ADDENDUM NO. THREE

DATE: November 15, 2013
DEPARTMENT: Internal Services Department (ISD)
ISD PROJECT NAME: Joseph Caleb Center New Parking Garage
ISD PROJECT NUMBER: Z00051-PG
BID DUE DATE: November 22, 2013 (REVISED)
CONTRACT COORDINATOR: Edgar Lugo, Project Manager

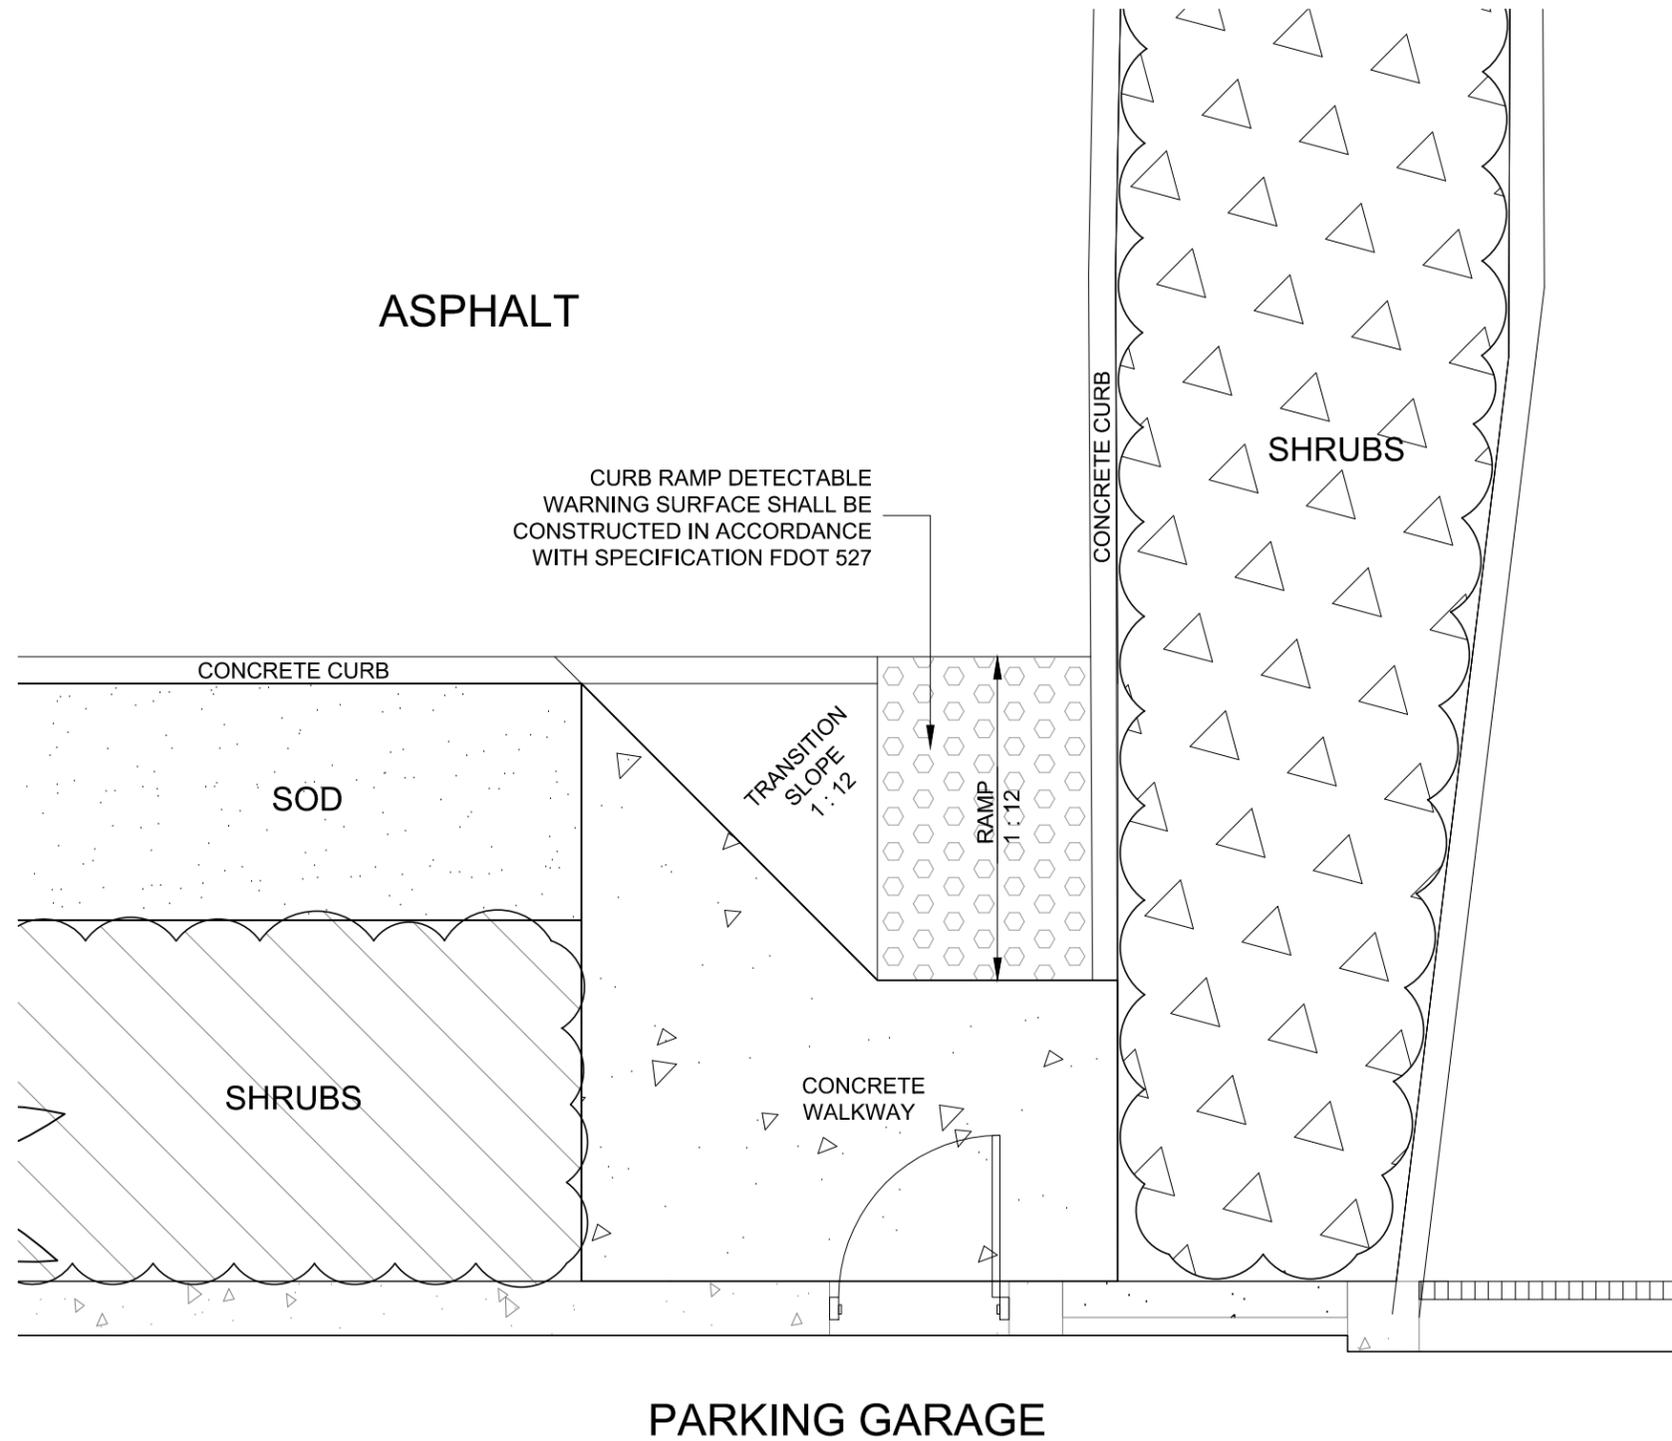
- Q32. Please clarify the following items as the information was not detailed on the plans.
1. Sheet A – 151 and A – 450, Ground Floor Plan shows room G114 (south of column grid line M) as Storage. Sheet A – 158 indicates the same space to be the generator room. Please clarify.

2. Sheet A – 551, wall section 5 shows the louver at the generator room. It further indicates "Refer to the MEP Plans and to Elevations for finishes and colors." Sheets A – 251 and A – 551, west elevation show the louver at center line of column grid line N, but do not indicate finishes and colors requirements. Sheet A – 603, #8 Louver Types does not provide the information. Sheet M – 150 Room G114 indicates louver by Arch. Please clarify and provide information.

- A32. 1. Yes, Room G114 is a storage room.
2. Refer to Sheet A-603 for information for louvers #1 and #2. Disregard all other louvers listed on this sheet and refer to mechanical drawings for size, type and location of all other louvers.
-

PARTIAL FOUNDATION PLAN (SOUTH)

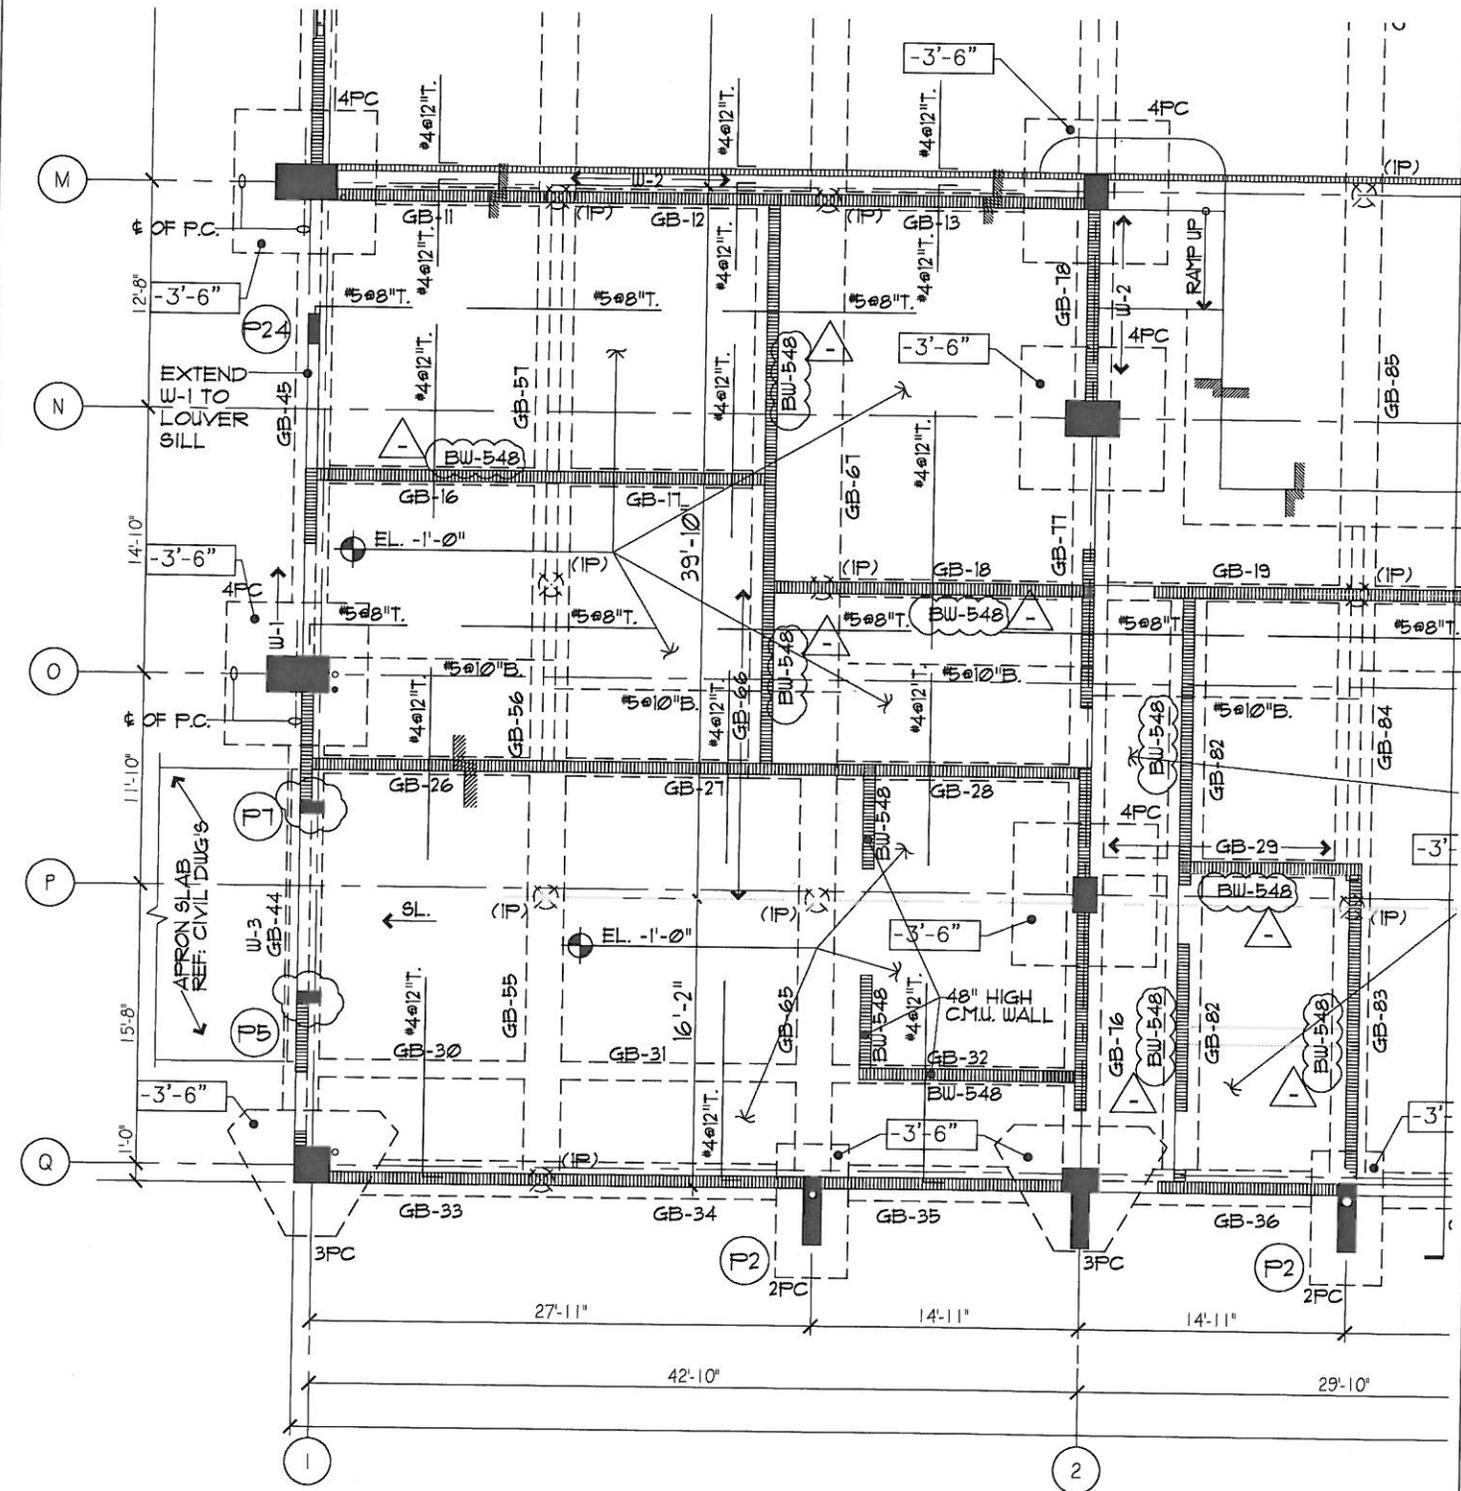
Q24.13. Sheet S-151 does not indicate wall designations to the interior walls at Rooms G108, G110, G112, G113, G114 and G115 with exception to the 42" high masonry walls. Sheet A-450 indicates these walls as masonry. Please provide masonry wall designation as indicated on Sheet S-203.

A24.13. See attached "Partial Foundation Plan (South)."
